**BOARD OF COUNTY COMMISSIONERS
POLK COUNTY, FLORIDA**

**ADDENDUM #6
BVP # 10-012-MAR**

**NEW HOLLY HILL WPF AND RECLAIM STORAGE &
REPUMP FACILITY**

1 STAINLESS STEEL WALL MANHOLE
W/ SMOOTH NOZZLE SAMPLE TAP

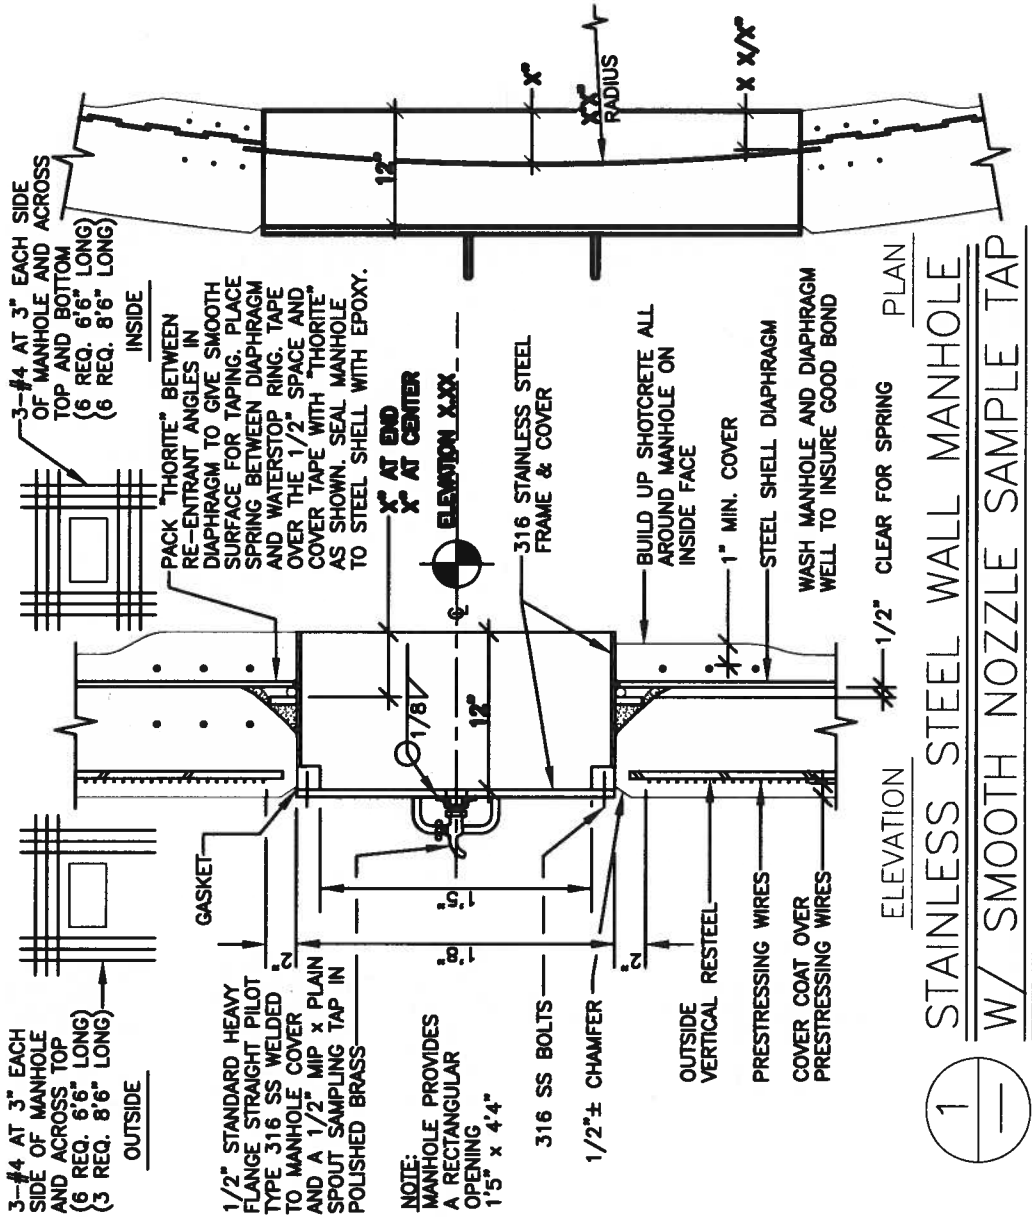
Question 8: Manhole Detail: Old detail, this type of manhole is not available.

Answer 8: See attached drawing.
